Product Change Notification

1. ECN #: 299762

- IDSD - INSULATION DISPLACEMENT TERMINAL CABLE

New modified body pic 1

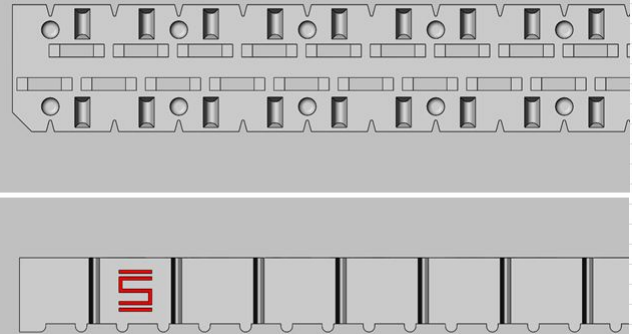
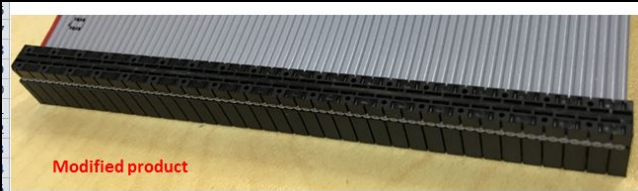
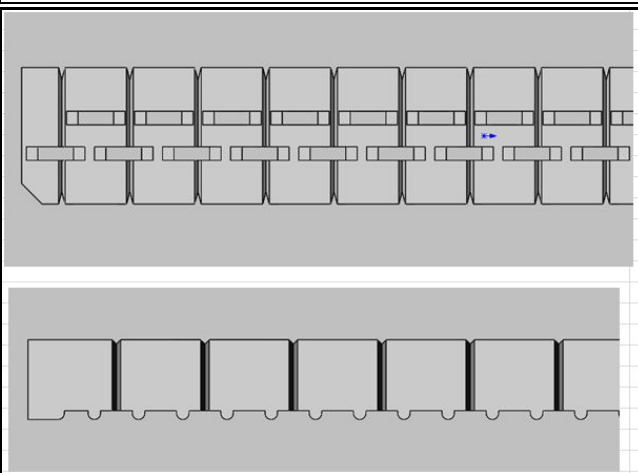
Add void corings on the top surface and change material from PBT VALOX DR-48 to PBT 4521.

Visual inspection; voids will be noticed on the top of body where prior revision had no voids; this is a rolling change and there is some opportunity for mixed inventory on a limited basis.
